**SYDNEY OPERA HOUSE  
PROPOSED MODIFICATION TO  
VEHICLE AND PEDESTRIAN SAFETY PROJECT (VAPS)  
(MP 09\_0200)**

**HERITAGE IMPACT STATEMENT**

**Final Report  
25 October 2012**

Amended photomontage showing proposed modification, based on an image by JPW for the original VAPS planning application  
(Image supplied by Scott Carver)

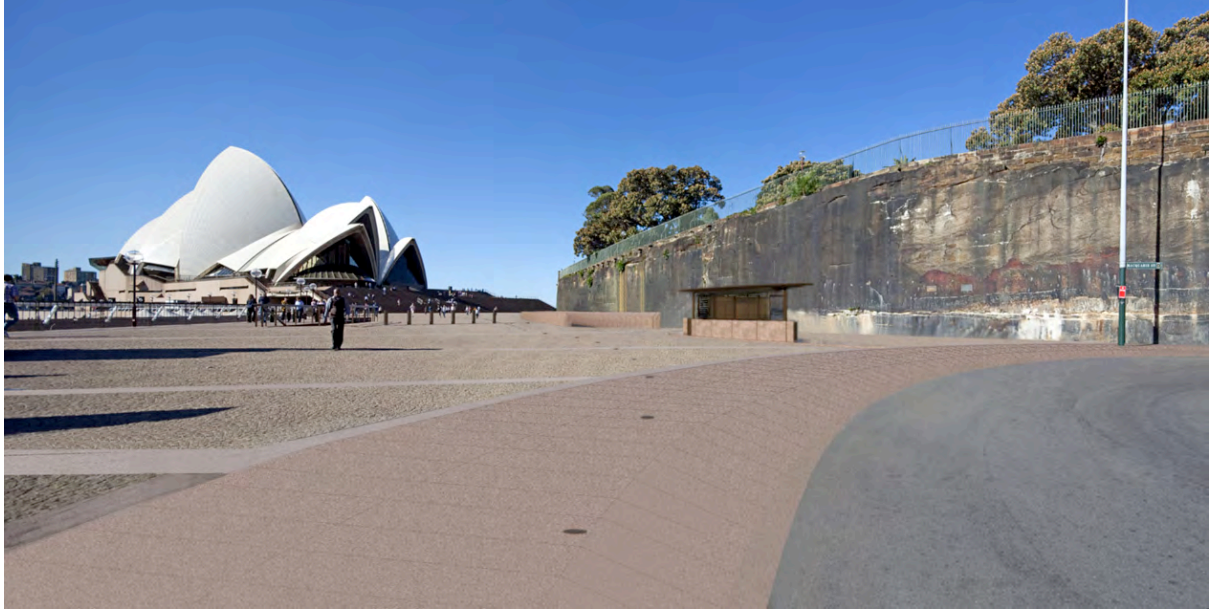
The proposed changes to the parapet and balustrade around the loading dock entry portal will have a significant impact on the setting of the forecourt because of their solidity and height, however this is mitigated by their simple design and use of elements consistent with Utzon's design elsewhere on the site. The open and unencumbered character of the forecourt and Tarpeian Wall as defining elements in the iconic presentation of the Opera House will not be substantially diminished.

The proposed changes to the approved design for the parapet around the loading dock entry portal will visually intrude into the southern edge of the Forecourt and conceal the lower part of the Tarpeian Wall, where it abuts this entry. The strength and simplicity of the proposed parapet design will mitigate these impacts on the Forecourt.

Illustration taken from Scott Carver drawing No. 49-FV-SC001-EA-140

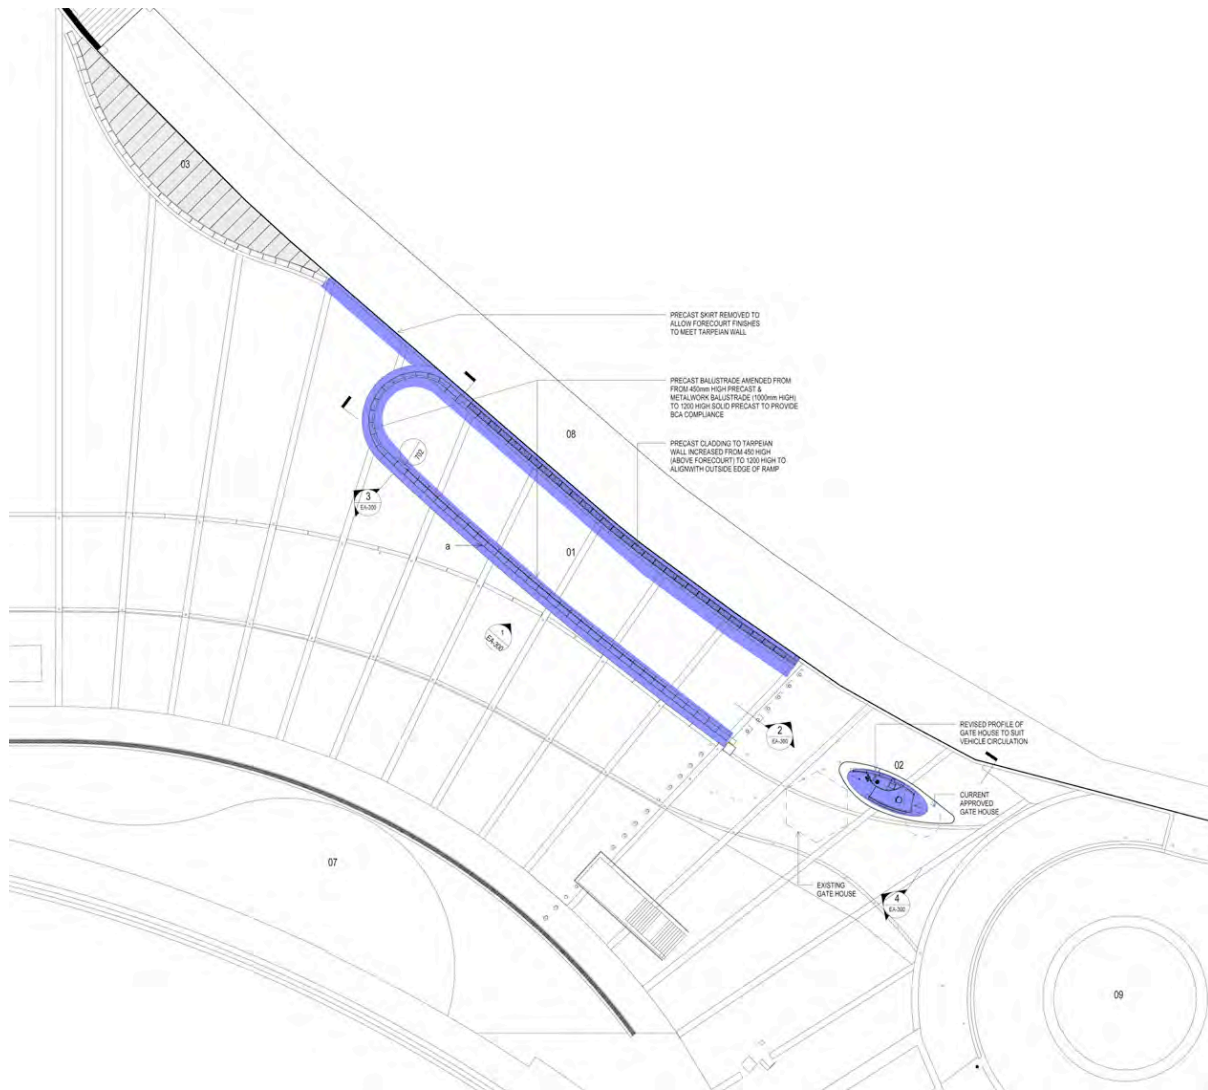
Revised balustrade to the perimeter of the opening at the entry to the underground loading dock in the forecourt. To address compliance issues, the approved 450mm high precast upstand with open metal balustrade above is proposed to be replaced with a 1200mm high solid precast parapet using the pink granite.

Associated with this is a raised height for the precast pink granite wall cladding against the Tarpeian Wall where it faces the ramp to match the proposed balustrade opposite.

It is now proposed to delete the precast upstand adjacent to the Tarpeian Wall between the east end of the opening for the loading dock entry ramp and the carpark vent structure to allow the base of the Tarpeian Wall to remain exposed.
